enquiries refer
Naomi McCarthy
in reply please quote
143-09/ DA 2018/321

**Re: Application for Site Compatibility Certificate – SEPP Housing for Seniors or People with a Disability) 2004
Lot 11 DP 1245510, 120 North Creek Road, Ballina**

Comments on Site Compatibility Certificate Application – 120 North Creek Road, Ballina – Palm Lake Works Pty Ltd

Palm Lake Resort, Ballina Proposed North Creek Road Upgrade - Coastal SEPP Legend

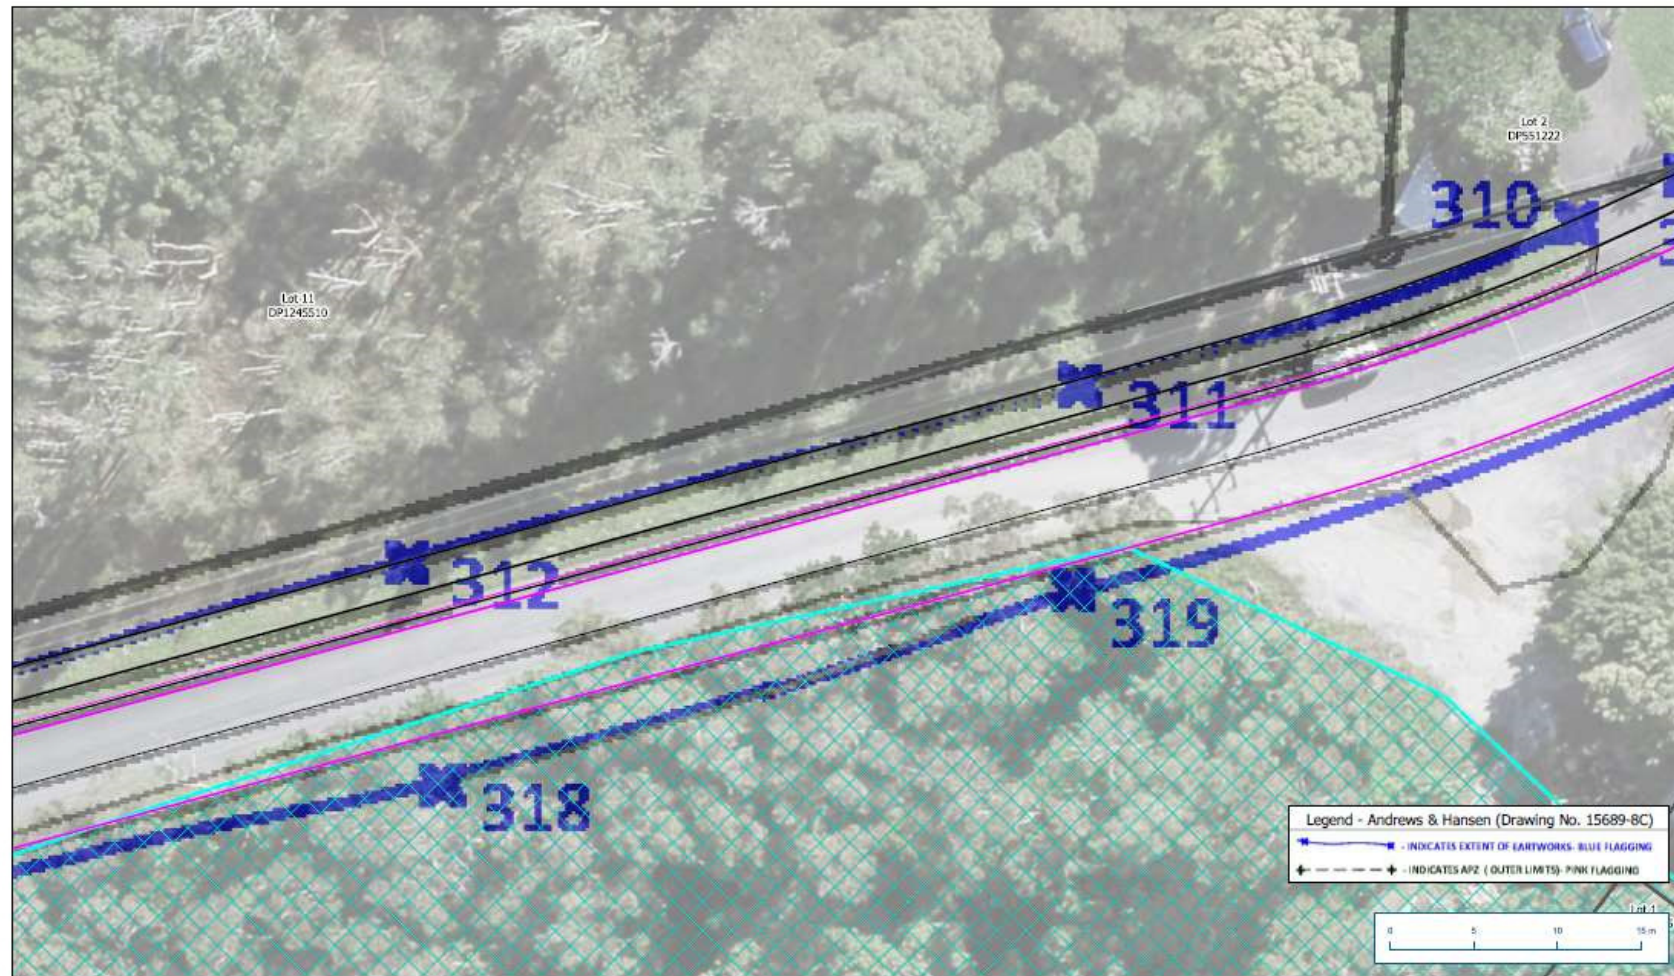
****Refer to the plan on the following page which shows the works to be carried out in the North Creek Road reserve overlain with the Coastal Wetland mapping. This was provided as part of the appeal for DA 2018/321.**

The SCC application states that the road upgrades will be dealt with by a separate Roads Act approval. If this was a vehicular crossing or a re-sheet of an existing road surface, that may be an appropriate way to deal with this matter, however this is not the case. Of direct relevance to this, is the findings and decision made by Chief Judge Preston on 29 April 2020, in relation to Council's appeal to the decision made by Commissioner Dickson.

In the alternative, if the works were confirmed to not encroach into wetlands (which is contrary to the preliminary design work carried out by the applicant as part of DA 2018/321 and as shown in the plan on page 17 of this response), the upgrade works may be considered as development without consent pursuant to clause 94(1) of the SEPP (Infrastructure) 2007, where it is carried out by or on behalf of a public authority. This would require the preparation of a Review of Environmental Factors or potentially an Environmental Impact Statement. This work has not been carried out and so there are questions raised and assessment pathways unknown.
